## SERVICE BULLETIN

**NUMBER:** DCI-EC130-IBF-SB01  
**Date:** 12 July 2021

**SUBJECT:** BACKSHELL FASTENER REPLACEMENT

Inlet Barrier Filter (IBF) systems, produced by the Donaldson Company, Inc. (DCI), formerly Aerospace Filtration Systems, Inc. (AFS), for following helicopter models:

**Figure 1 – Location of Backshell Screws Recommended for Replacement (I)**

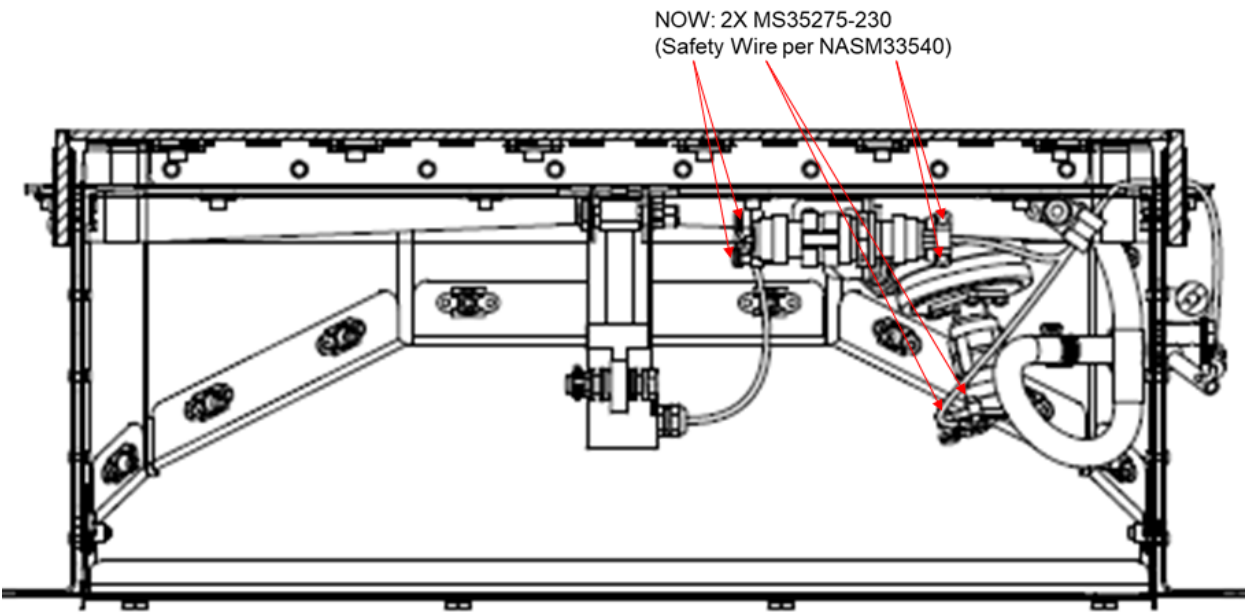
Donaldson was notified by one of its customers operating a DCI EC130 IBF system that during the regular scheduled maintenance interval of the IBF system, a fastener was found to become loose. The source of the loose fastener was discovered to be from a Backshell on the IBF system's wire harness. The Backshell is a military specification component.

This is not a safety of flight issue, if operators follow Section 8.5.5.2 of the Instructions for Continued Airworthiness (ICA) and verify that Backshells are secure during regular maintenance intervals, then it is highly unlikely that the Backshell fasteners will come loose during flight. Nonetheless, Donaldson recommends a product improvement for all operators of the DCI EC130 IBF by replacing the existing fasteners on the Backshells of the 106113-205 Actuator and the 121400-101 Wire Harness with MS35275-230 screws and to safety wire the screws per NASM33540. Location of these screws can be found depicted in Figures 1 and 2. Inspection requirements for the Backshells will remain the same unless otherwise directed by a newer revision of the ICA (Reference 1).

Operators are recommended to locally procure the replacement hardware as applicable. If local procurement is not available, operators can procure the screws from Donaldson's ecommerce site found in the Contact section.
